20240544: Land to East and West of Gold Street, Sole Street, Nr Cobham, Kent, DA12 3AA

Application to determine if prior approval is required for a proposed; Erection of a winery building and hardstanding for Agricultural or Forestry use of the Town and Country Planning (General Permitted Development) (England) Order 2015 (as amended) - Schedule 2, Part 6.

Representation Statement

July 2024

Figure 4.2: Proposed barn location (with access subject to separate procedures)

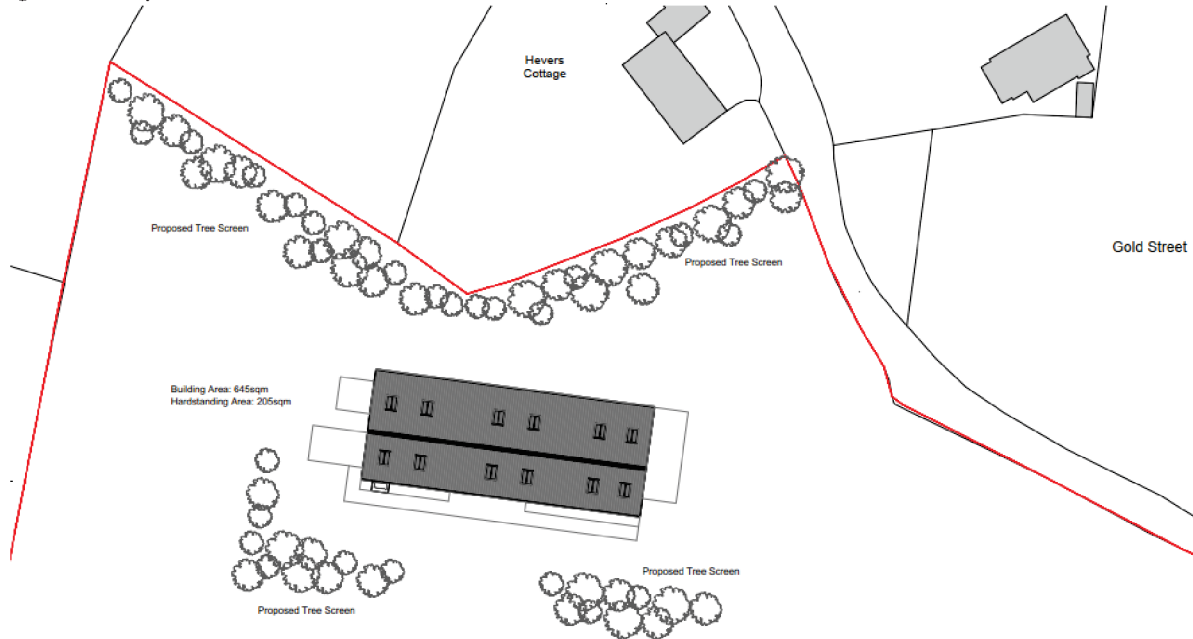
55. It is noted within the Chris Wood Acoustics Noise Assessment page 12, but provided at **Appendix A** for ease of reference that a brand new two-way vehicular access is likely to be proposed in the future. Figure 4.2 (on page 12) includes an annotation stating “*subject to separate procedures*”. Such detail is not provided within the Planning Statement where access is only mentioned regarding previous applications, or detailed on the Proposed Block Plan or has been included within the calculations for hardstanding areas.

58. Figure 4.2 on Page 12 details a visibility splay for the proposed future access. We point out that this does not achieve the required 215m in either direction as befits Gold Street and the splay shown has been drawn incorrectly.

59. It should also be noted that the proposed new vehicular access and associated access route is unscreened and given the volume of traffic generated will impact the Area of Outstanding Natural Beauty.
